**CITY OF MERIDIAN  
FINDINGS OF FACT, CONCLUSIONS OF LAW  
AND  
DECISION & ORDER**

**In the Matter of the Request for Conditional Use Permit for a Multi-family Development Consisting of 84 Dwelling Units on 3.49 Acres of Land in the R-40 Zoning District for Delano Apartments, Located at 3850 N. Centrepoint Way, by Becky McKay, Engineering Solutions, LLP.**

**Case No(s). H-2022-0082**

## STAFF REPORT COMMUNITY DEVELOPMENT DEPARTMENT

SHEET  
**AS1.0**  
 SITE PLAN

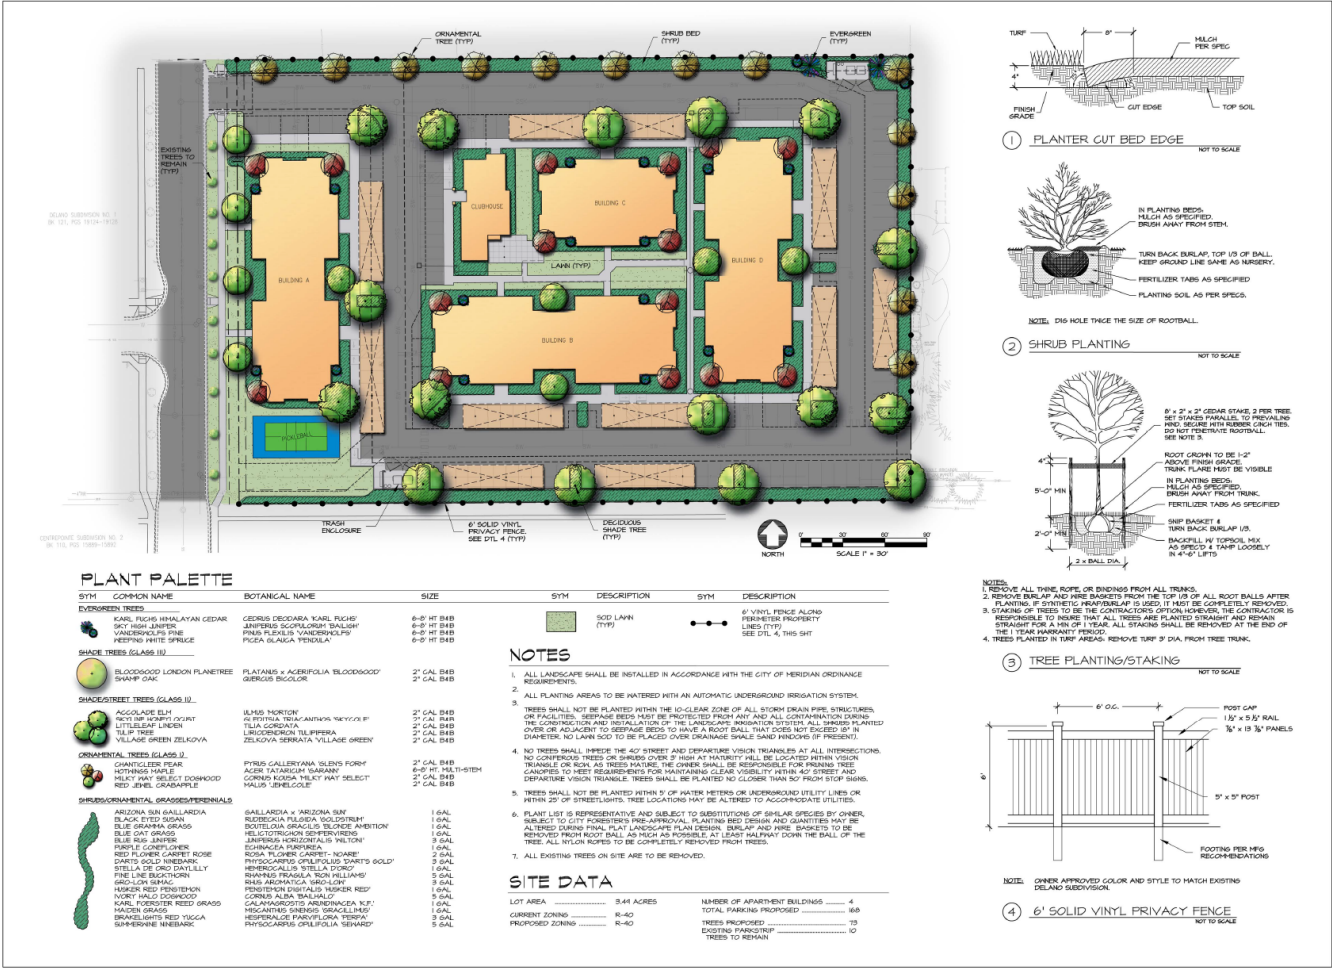
**Staff recommends the Applicant work with the property owner of the development (Brickyard apartments) to the south to see if they'd be amenable to removing a section of the existing fence between the two properties to allow for pedestrian interconnectivity between developments as desired in mixed-use designated areas such as this. If so, the site/landscape plans should be revised accordingly.**

**Fencing:** A 6-foot tall solid vinyl fence is proposed along the north, east and south sides of the development as shown on the landscape plan. Staff clarified with the Applicant the fence depicted along the southern boundary is actually the existing fence constructed with the adjacent development to the south; double fencing is not proposed or allowed. **Staff recommends the Applicant work with the property owner to the south to create a break in the fence to allow interconnectivity between developments.**

1. Buildings shall provide a minimum setback of ten feet (10') unless a greater setback is otherwise required by this title and/or [title 10](#) of this Code. Building setbacks shall take into account windows, entrances, porches and patios, and how they impact adjacent properties. *The proposed multi-family structures comply with the minimum setbacks required for the R-40 zoning district listed in UDC [Table 11-2A-8](#); however, the carports proposed along the south & east boundaries of the site do not. **The south and east perimeter buffers should be widened to 12 feet to accommodate a minimum 12-foot wide building setback for the carport structures, in accord with UDC [11-4-3-27B.1](#).***

2. All on-site service areas, outdoor storage areas, waste storage, disposal facilities, and transformer and utility vaults shall be located in an area not visible from a public street, or shall be fully screened from view from a public street. *The site plan depicts two (2) trash enclosures that are screened and not visible from a public street; **all proposed transformer/utility vaults and other service areas shall comply with this requirement. The trash enclosure should accommodate recycling.***

*The site plan states the property management office and maintenance storage area will be located in the clubhouse. Mailboxes are proposed on the outer wall of each of the two (2) trash enclosures. A directory and map are proposed to be provided at the clubhouse. **The site plan and floor plans submitted with the Certificate of Zoning Compliance application should depict the location of these items in accord with this standard.***

Unless otherwise approved through the conditional use process, common open space areas shall not be adjacent to collector or arterial street buffers unless separated from the street by a berm or constructed barrier at least four feet (4') in height, with breaks in the berm or barrier to allow for pedestrian access. (Ord. 09-1394, 3-3-2009, eff. retroactive to 2-4-2009) ***Some of the common open space is located adjacent to a collector street (Centrepont Way) – Commission approval is needed in order for these areas to qualify toward the open space requirement. The two (2) northern areas depicted on the open space exhibit aren't really recreation areas but the southern area where the pickleball court is proposed is. Therefore, if approved by the Commission, Staff recommends a berm or constructed barrier is constructed between the pickleball court and the street buffer in accord with this requirement.***

5. Comply with building code requirements for separation between structures within the development.
6. The Applicant should work with the property owner of the development (Brickyard apartments) to the south to see if they'd be amenable to removing a section of the existing fence between the two properties to allow for pedestrian interconnectivity between developments as desired in mixed use designated areas such as this. If so, the site/landscape plans should be revised accordingly.

9. The trash enclosures shall accommodate recycling.
10. The site and/or landscape plan submitted with the Certificate of Zoning Compliance shall be revised as follows:

**DELANO APARTMENTS**  
 MERIDIAN, IDAHO  
 CUP LANDSCAPE PLAN

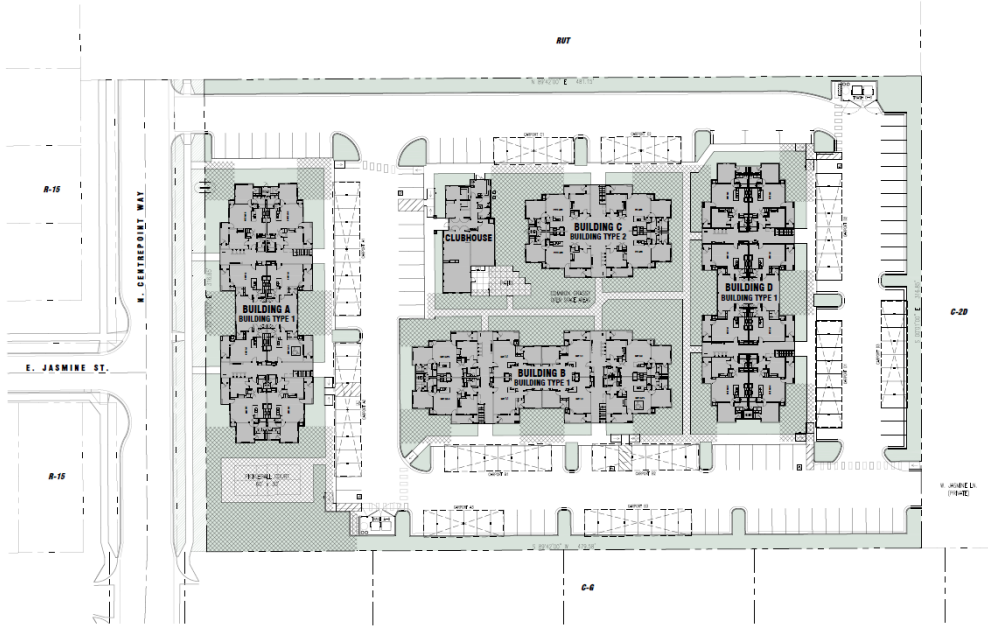
- E. Landscaping Requirements: Development shall meet the minimum landscaping requirements in accord with chapter 3, "Regulations Applying to All Districts", of this title. Additionally, all street facing elevations shall have landscaping along their foundation that complies with the standards listed in UDC [11-4-3-27E.2](#). ***The landscape plan submitted with the Certificate of Zoning***

**Compliance application should depict landscaping along the street facing elevation of Building A adjacent to N. Centrepont Way in accord with these standards. Landscaping is required to be provided along all pathways per the standards listed in UDC 11-3B-12C. Street buffer landscaping along N. Centrepont Way, a collector street, was installed with the subdivision improvements.**

SHEET  
**AA5.0**  
BUILDING ELEVATIONS

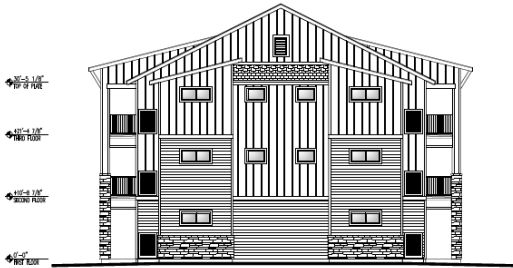
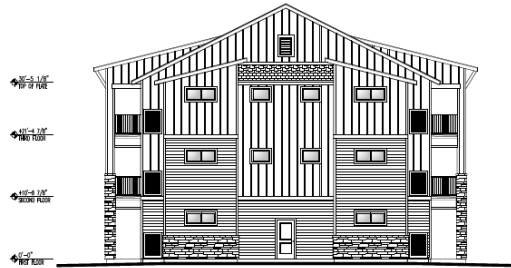
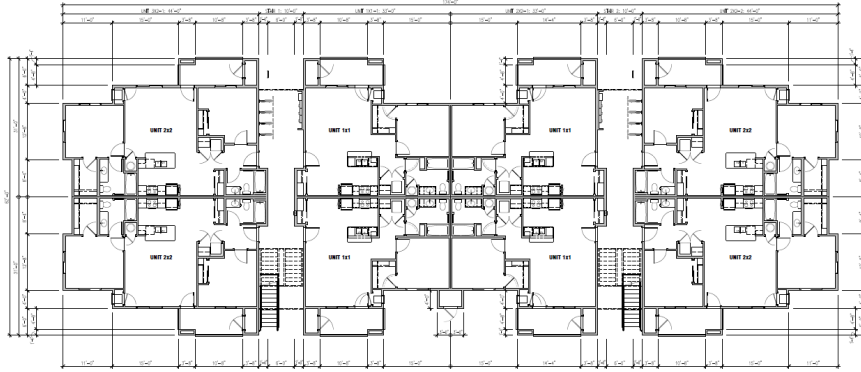
**Building Elevations** (UDC [11-3A-19](#) | [Architectural Standards Manual](#)): Conceptual building elevations of the multi-family structures were submitted with the annexation application for Delano subdivision as shown below. The existing Development Agreement (DA) requires future development to be generally consistent with those elevations and comply with the design standards in the Architectural Standards Manual.

While the *style* of the proposed elevations is not really consistent with the conceptual elevations included in the DA, they are consistent in *form* in that they are both 3-stories in height with balconies and patios for each unit with a variety of materials and have similar modulation. The proposed elevations have pitched roofs with architectural asphalt shingles, vertical fiber cement board and batten siding, fiber cement horizontal lap siding with stone wainscot accents. Staff is of the opinion the proposed design is preferable as it’s more consistent with the style of residential structures in the surrounding area and will blend better. Therefore, Staff does not recommend a modification to the DA.

Final design of all structures is required to comply with the design standards in the Architectural Standards Manual and will be reviewed for compliance with these standards with the Design Review application. **Compliance with the building code requirements for separation between structures within the development is required.**
